**FINAL DRAFT INTERIM MEASURE/INTERIM
REMEDIAL ACTION FOR
THE ORIGINAL LANDFILL
(INCLUDING IHSS GROUP SW-2;
IHSS 115, ORIGINAL LANDFILL
AND IHSS 196, FILTER BACKWASH POND)**

December 6, 2004 February 15, 2005

**ADMIN RECORD
IA-A-002613**

Figure 4-17 Dissolved Strontium-90 in Groundwater

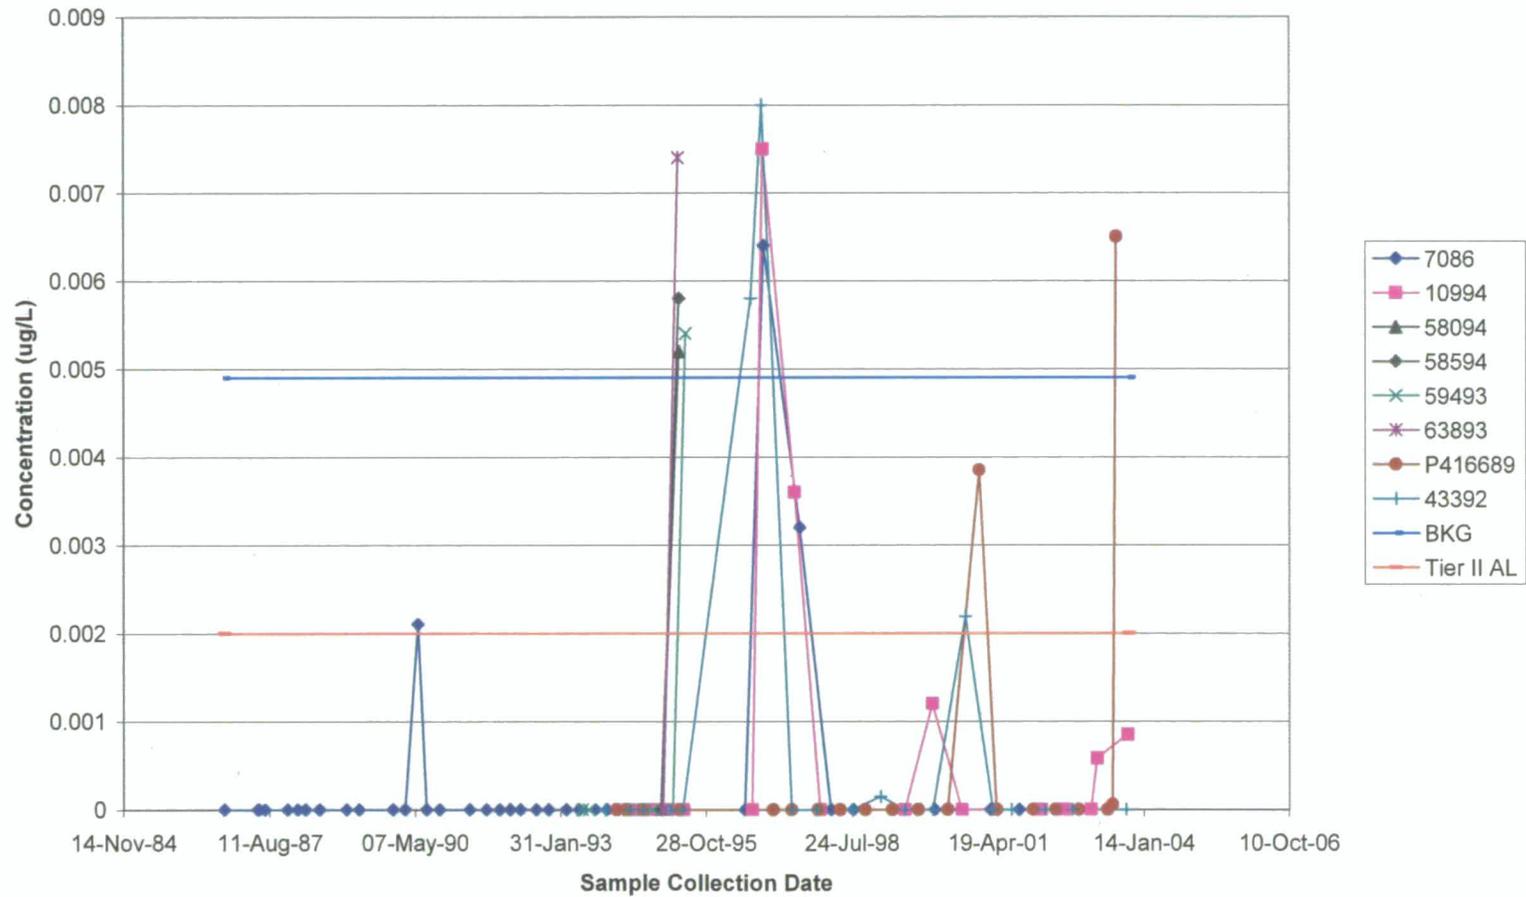
5.2	Clarify the source of strontium-90 in the groundwater wells.	Figure 4-17 indicates that strontium-90 concentrations fluctuate around the background concentration, which indicates the strontium-90 is largely at

**Figure 6.1
Conceptual Surface
Grading Plan**

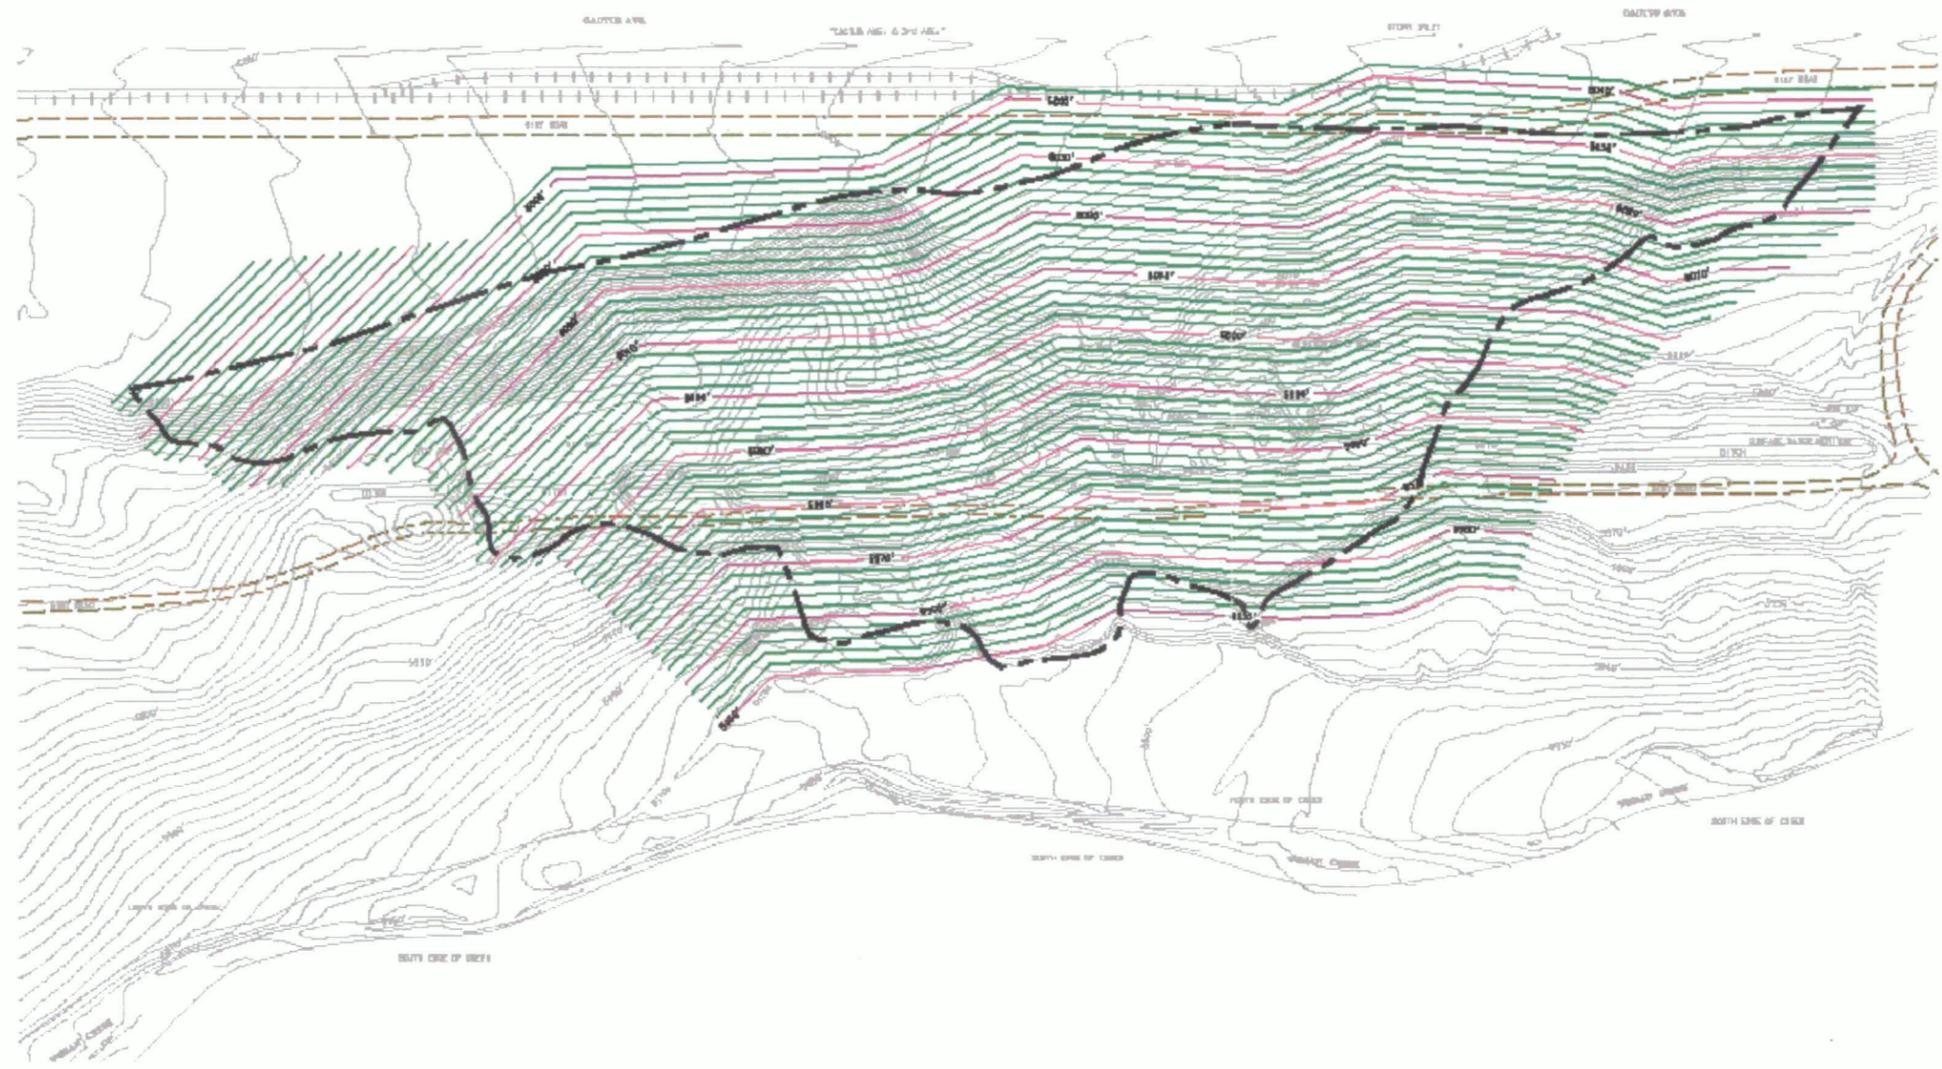
24		Figure 6.1, Conceptual Surface Grading Plan – Some of the contours do not match the adjacent contours. The grading plan should try to match the existing contours in adjacent hillsides as much as possible. It may be best to include the area east of the landfill up to the existing road to match the contours.	This figure is a conceptualization of the new cover slope. The final design will establish the final grades and will be designed to match the existing contours adjacent to the OLF.
25		Section 6.1.2, page 6-5, second paragraph – How was a thickness of 2 feet determined? Why not one foot, or three feet, or even four feet? Please describe how this depth was determined. Will there be monitoring to ensure that the minimum soil depth is retained over the long-term?	A 2-foot soil cover is commonly used for municipal landfill covers and is appropriate for the cover at the OLF since the majority of the waste material is construction debris and solid waste (trash). Two feet is the minimum required cover under current Municipal Landfill regulations governing closure of sanitary landfills. We believe this thickness to be sufficient for long-term effectiveness in preventing direct contact with landfill soil and commingled debris.
